*MWO 11-5820-298-35/1

DEPARTMENT OF THE ARMY MODIFICATION WORK ORDER

MODIFICATION OF RADIO RECEIVERS R-274A/FRR (HAMMARLUND MODEL SP-600-JX), AND R-320A/FRC (HAMMARLUND MODEL SP-600-J) TO PROVIDE MORE ADEQUATE FUSING OF THE POWER TRANSFORMER AND TO PROVIDE BETTER ACCESSIBILITY TO THE B MINUS FUSE

MODIFICATION OF RADIO RECEIVERS R-274A/FRR,
R-274C/FRR, R-320A/FRC, AND THE HAMMARLUND
RADIO RECEIVERS SP-600-JX AND SP-600-JLX,
TO IMPROVE SIGNAL-TO-NOISE RATIO ON AGC OR
MGC OPERATION AND TO PREVENT BLOCKING OF
THE FIRST MIXER TUBE

Figure 7. Original wiring of r-f strip.

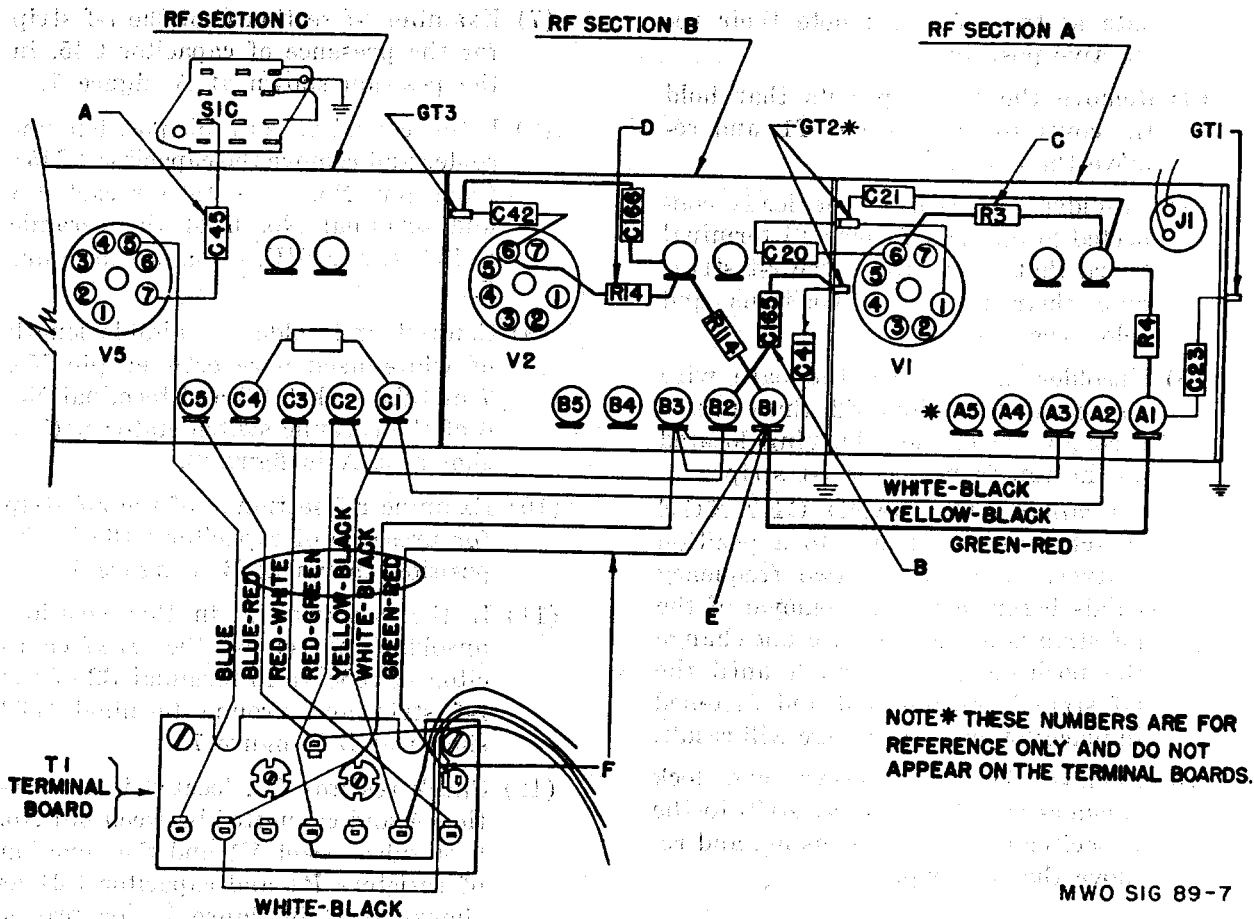
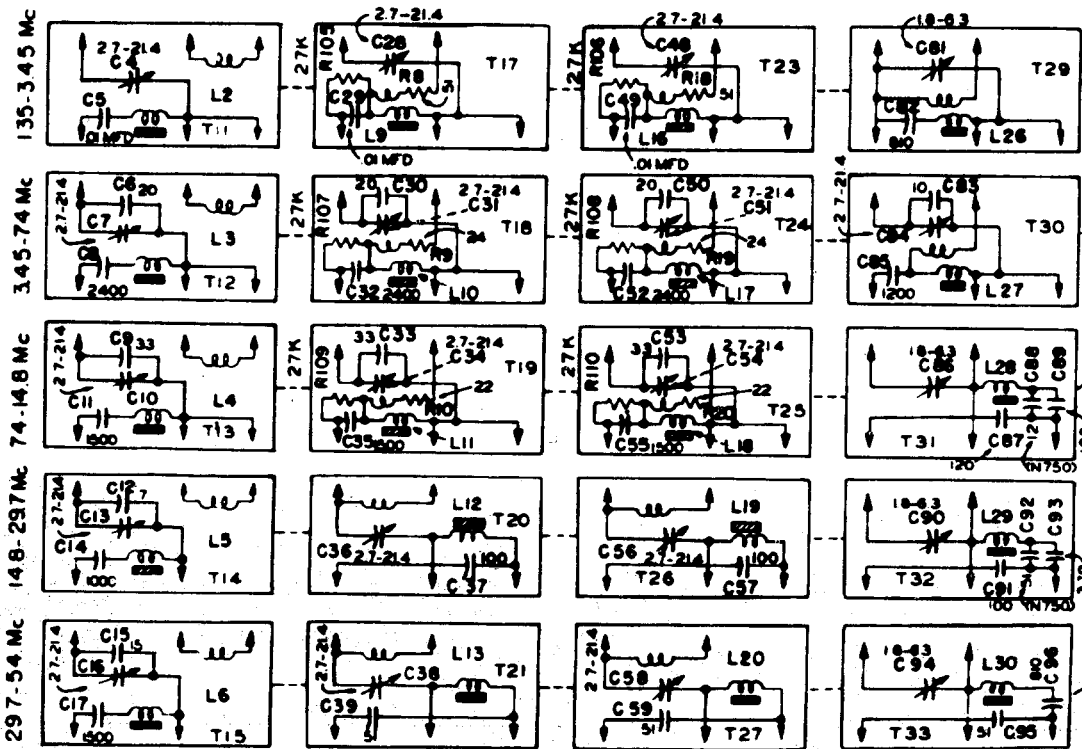
- (7) Examine r-f section C of the r-f strip for the presence of capacitor C45, in the position shown at A, figure 7.
- (8) If this capacitor is in this position, unsolder and remove the capacitor (C45) from pin No. 7 of tube socket V5 and terminal No. 6 of the ceramic switch stator S1C, as shown in figure 7.

- (10) Examine r-f section B of the r-f strip for presence of capacitor C165 in the position shown at B in figure 7.
- (11) If the capacitor is in this position, unsolder and remove the .01- μ f capacitor (C165) from terminal B2 of the r-f strip and ground terminal GT2 shown at B in figure 7.

- (12) Check resistor R3, located in r-f section A and connected between pin No. 6 of tube socket V1 and the junction of resistors R4 and capacitor C21 as shown at C in figure 7, for proper resistance value. Where this resistor is found to be other than 33,000 ohms, replace it with a 33,000-ohm, $\frac{1}{2}$ -watt resistor.

Figure 8. New connection of r-f strip.

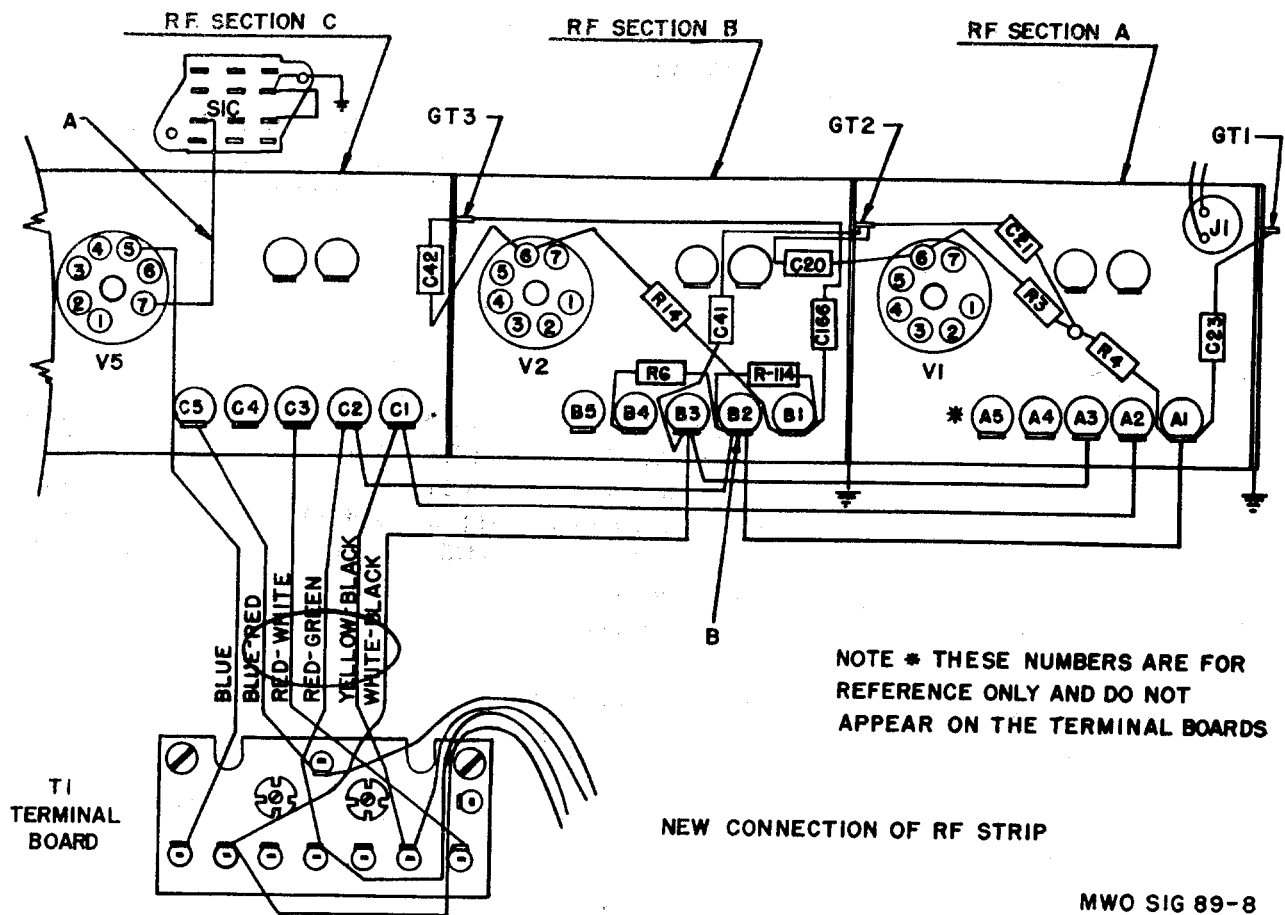
- (9) Connect and solder a suitable length of white-black wire between pin No. 7 of tube socket V5 and terminal No. 6 of the ceramic switch stator S1C as shown at A in figure 8.

- (14) Connect and solder a .01- μ f capacitor (C156) between terminal B1 and chassis ground terminal GT3 as shown in figure 8, if one is not connected in this position.

Page 9. Paragraph 10i(14). Change subparagraph (14) to read: Connect and solder a 0.01 μ f, 600 vdcw capacitor (C166) between terminal B1 and chassis ground terminal GT3 as shown in figure 8, if a capacitor is not already connected in this position.

Figure 11. Installation of new resistors.

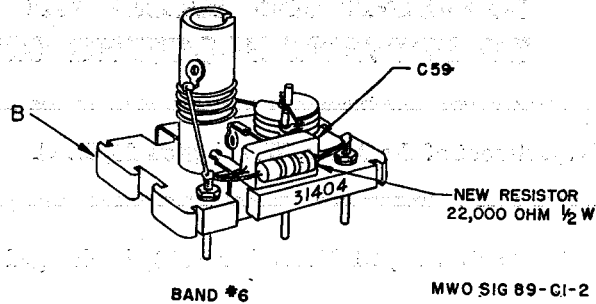
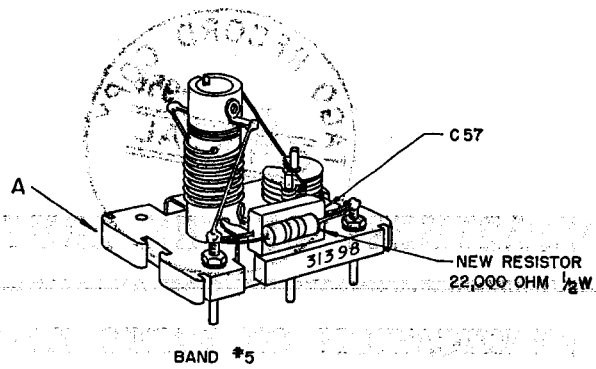
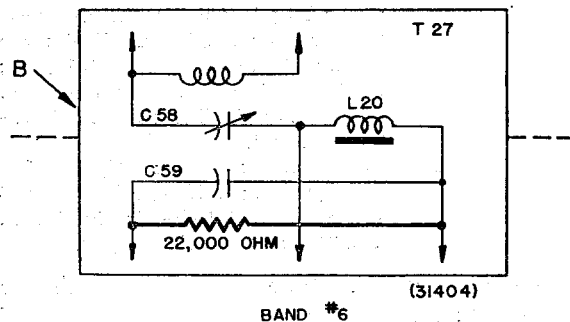
- (d) Connect and solder a 22,000-ohm, 1/2-watt resistor across capacitor C57 in the rf interstage subassemblies for band 5, as shown at A, figure 11.
- (e) Check the wiring in accordance with the wiring diagram of the rf interstage subassemblies for band 5 as shown at A, figure 12.
- (f) Connect and solder a 22,000-ohm, 1/2-watt resistor across capacitor C59 in the rf interstage subassemblies for band 6 as shown at B, figure 11.

Figure 12. Revised circuit diagrams of the rf interstage subassemblies for bands 5 and 6.

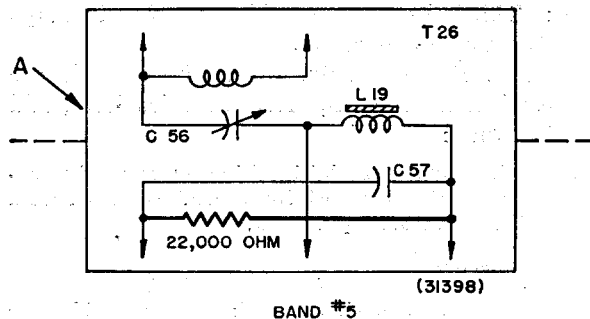
NOTE: HEAVY LINES DENOTE MODIFICATION

- (g) Check the wiring with the wiring diagram of the rf interstage subassemblies for band 6 as shown at B, figure 12.
- (h) Replace the rf interstage subassemblies for bands 5 and 6 to the rf tuning unit rotary turret in their original position. Use the original flat springs.
- (i) Replace the bottom cover to the tuning unit housing; use the original screws and lockwashers.

- (29) With suitable ink, insert the circuit changes contained in figure 12, into
